ATTACHMENT I

Re: Turkey Point Units 3 and 4
Docket Nos. 50-250 and 50-251
Proposed License Amendment
Revised Technical Specifications

MARKUP OF FINAL DRAFT
OF TECHNICAL SPECIFICATIONS

FIGURE 2.1-1
REACTOR CORE SAFETY LIMIT - THREE LOOPS IN OPERATION

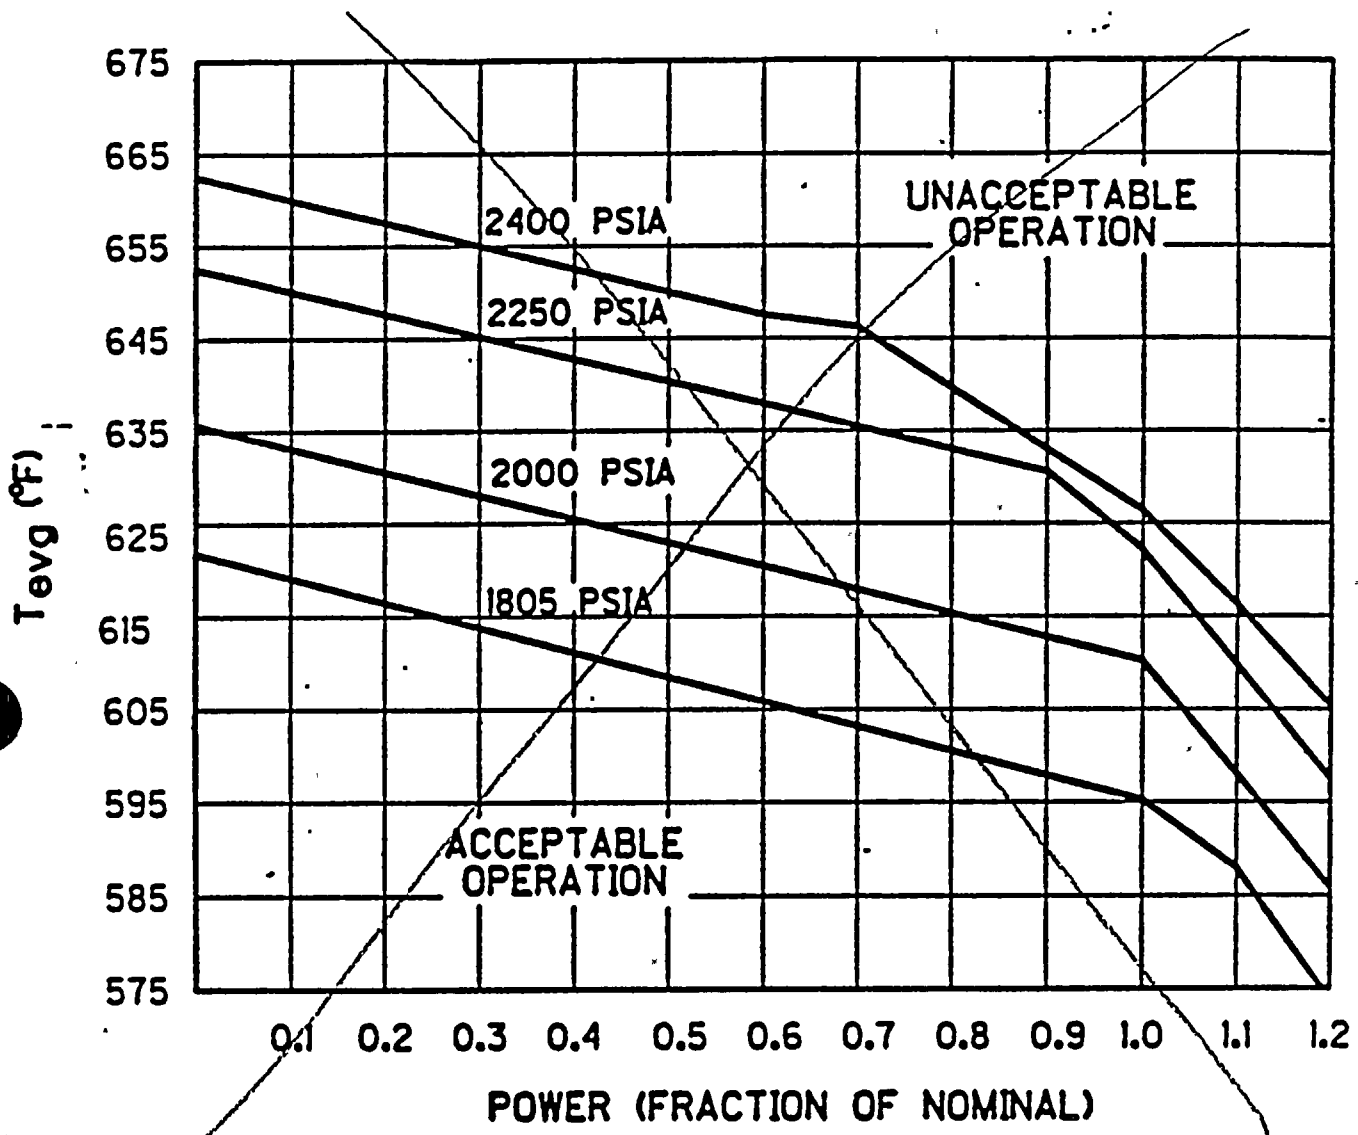
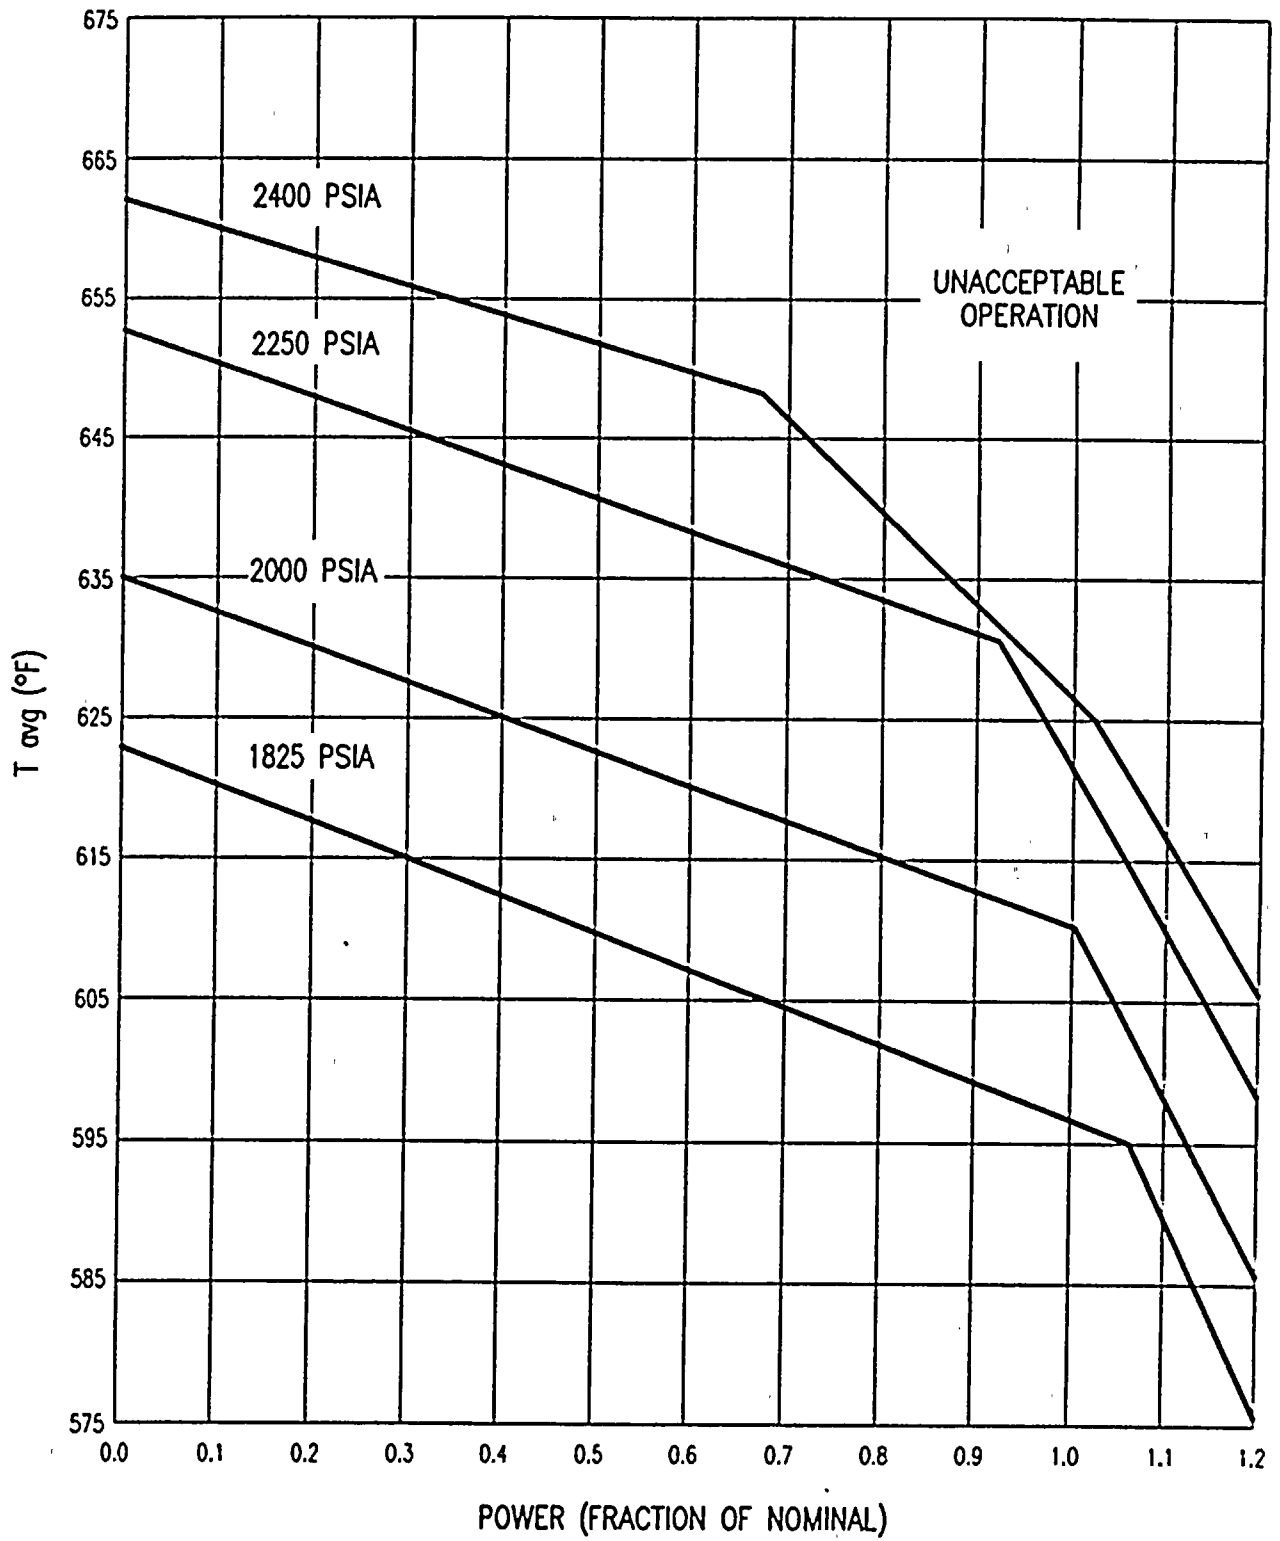
See next page

Figure 3.1-1
Required Shutdown Margin vs Reactor Coolant
Boron Concentration

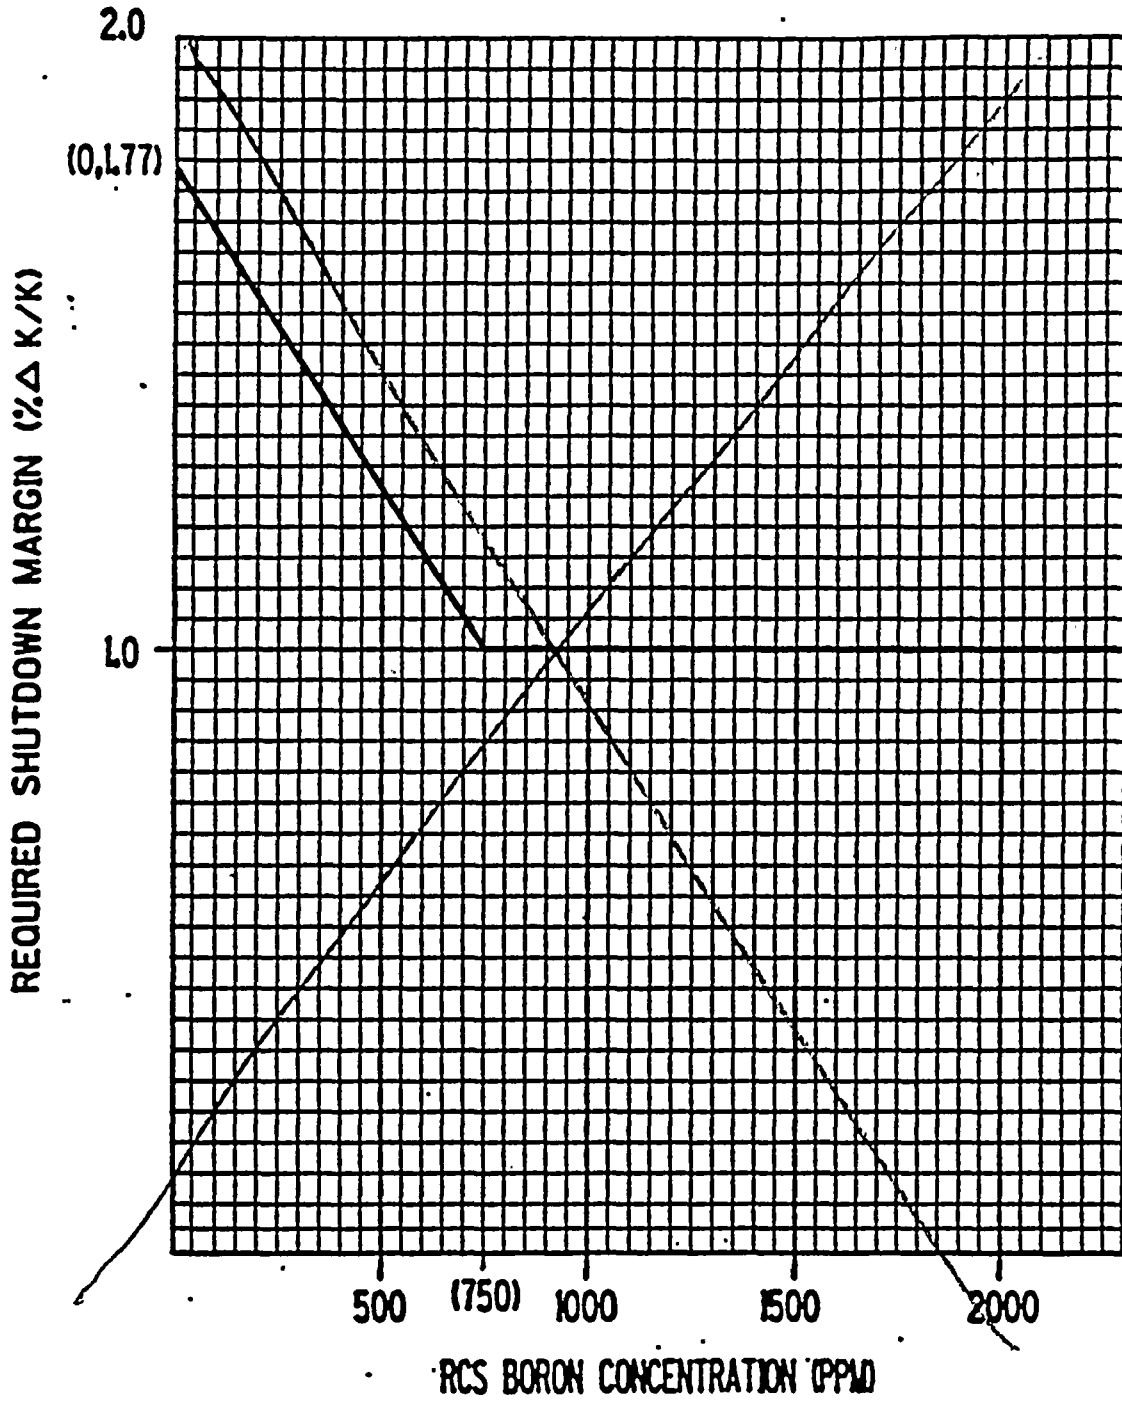
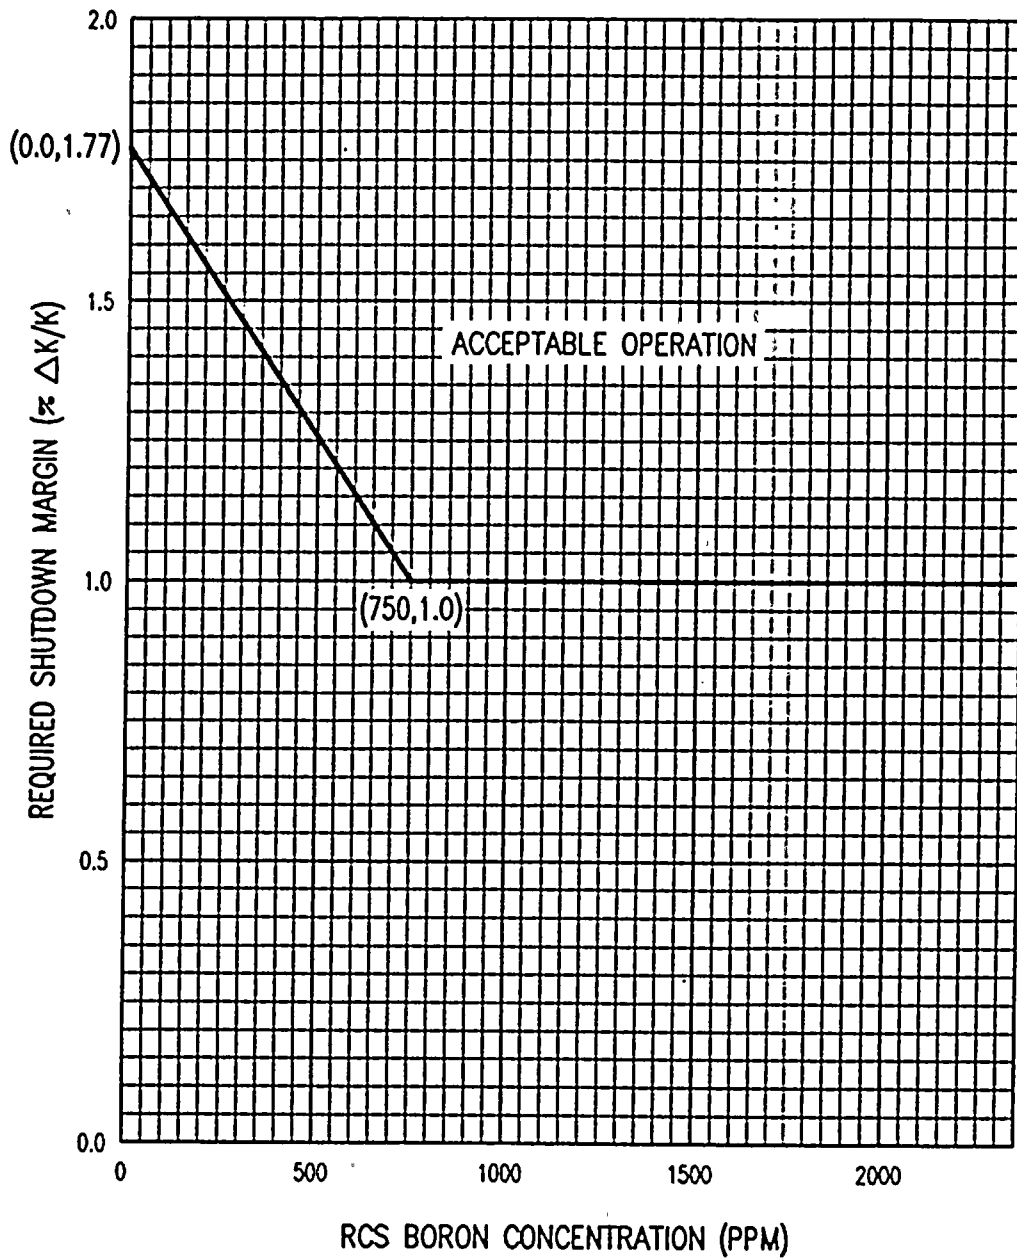
See next Page

FIGURE 3.1-2
 ROD BANK INSERTION LIMITS VERSUS THERMAL POWER
 THREE LOOP OPERATION

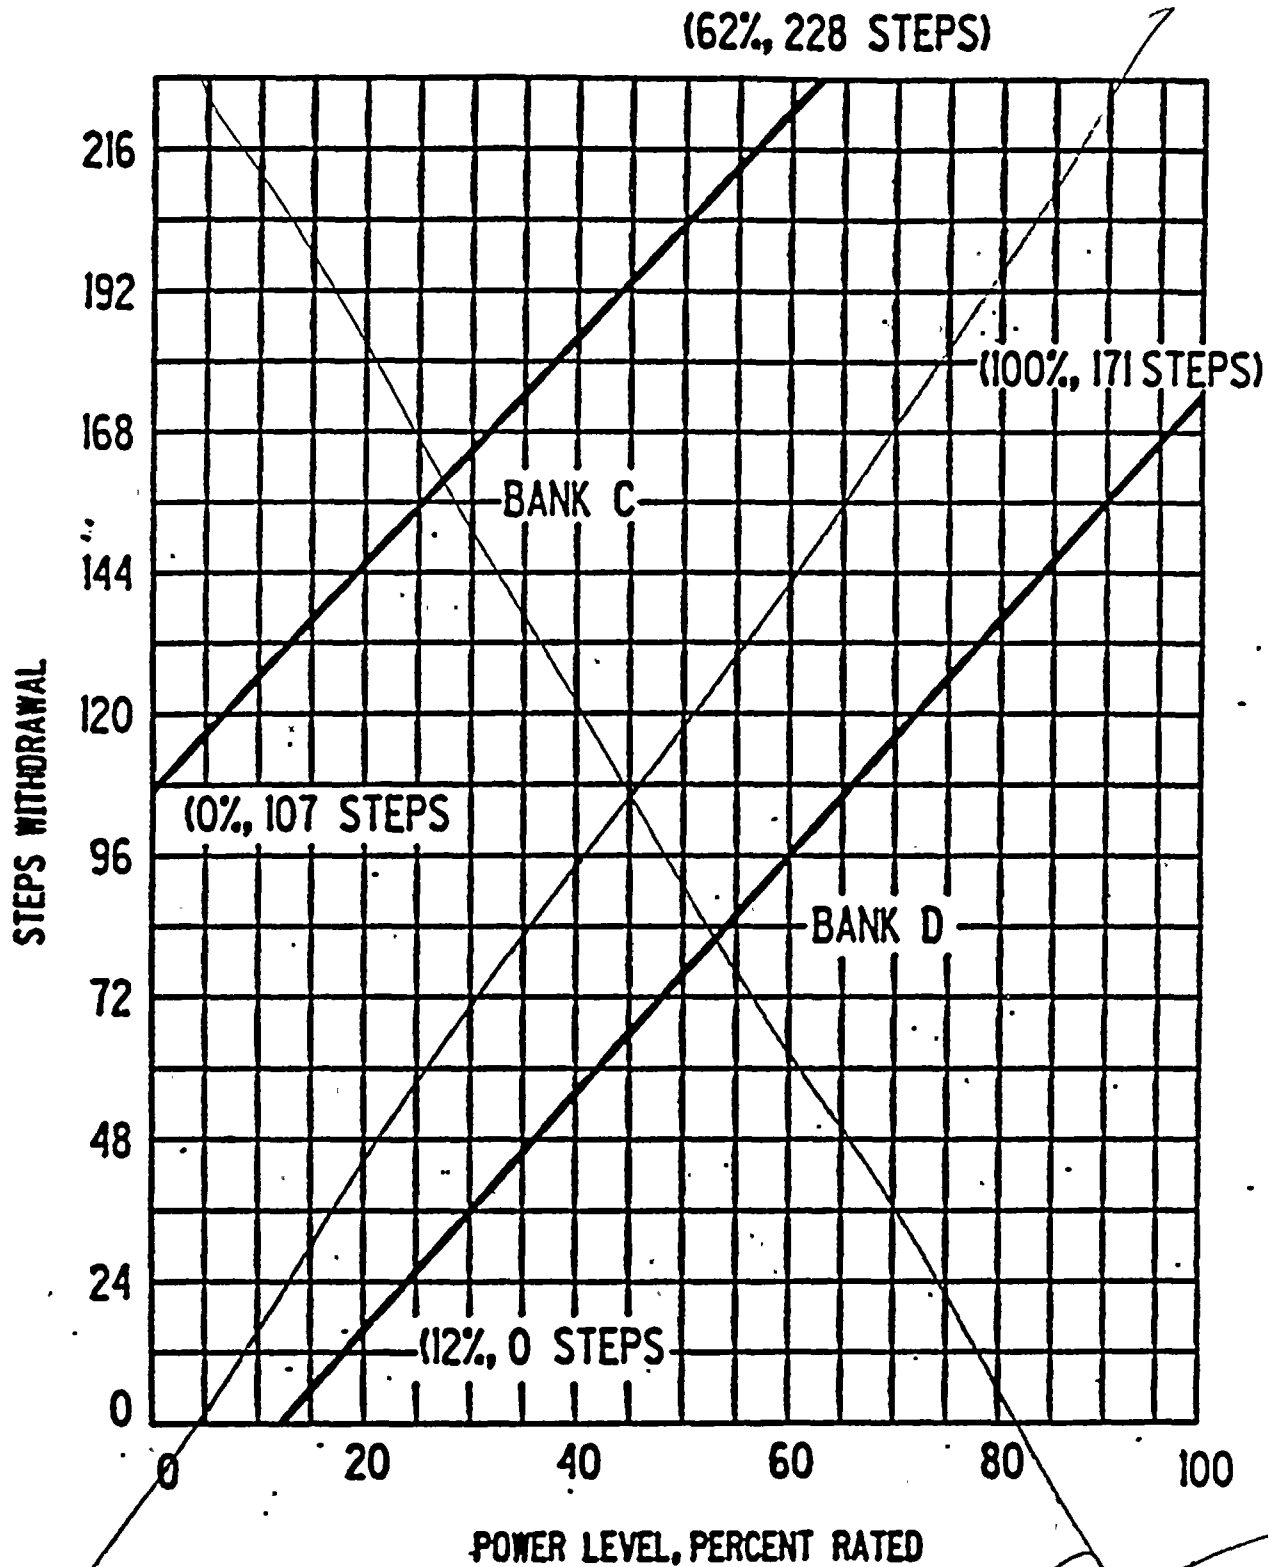
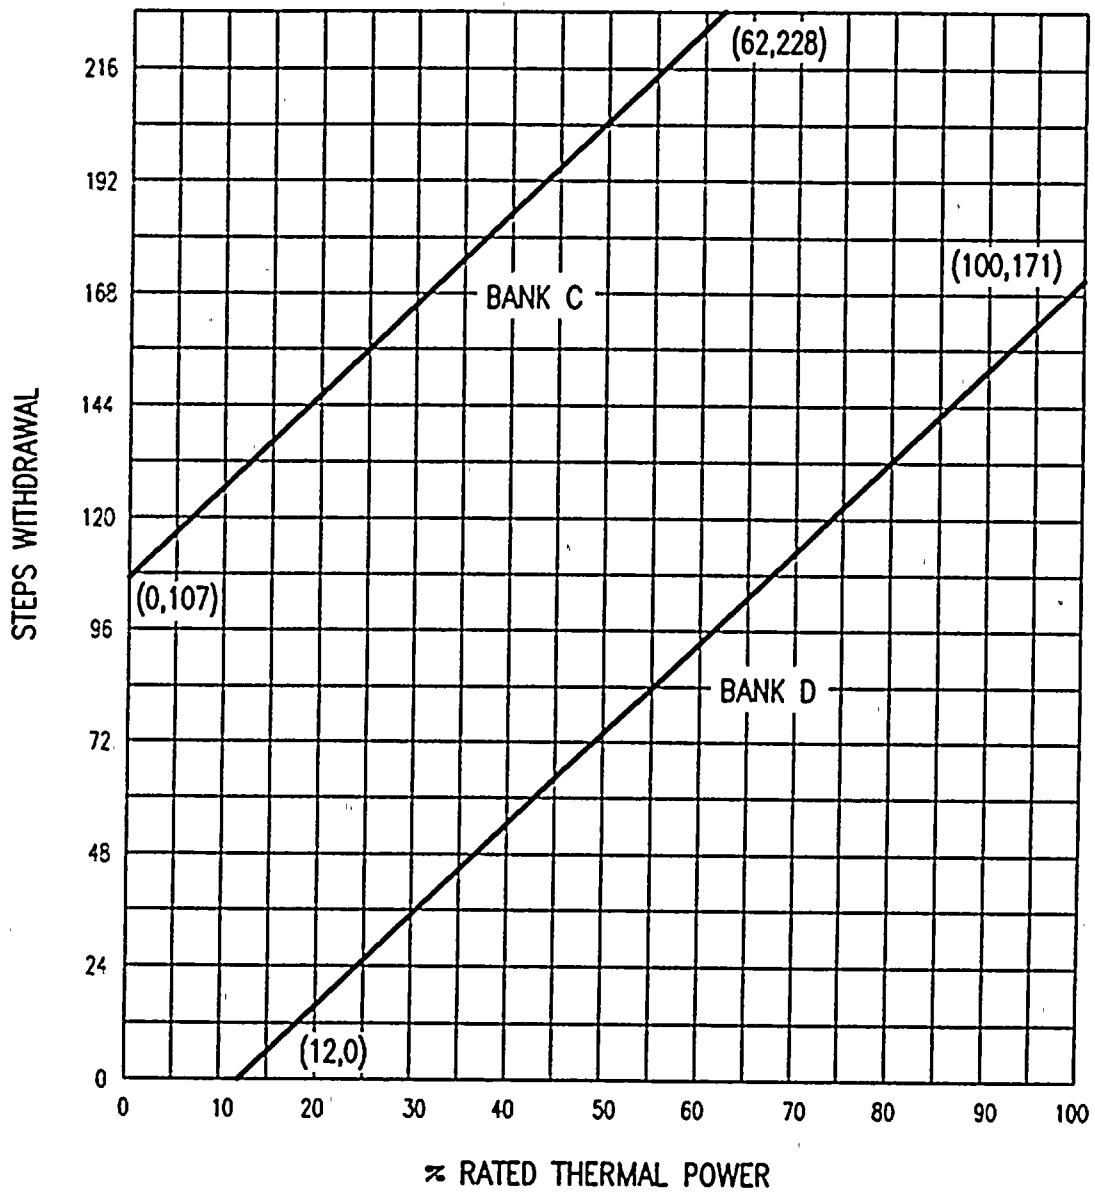
See next page
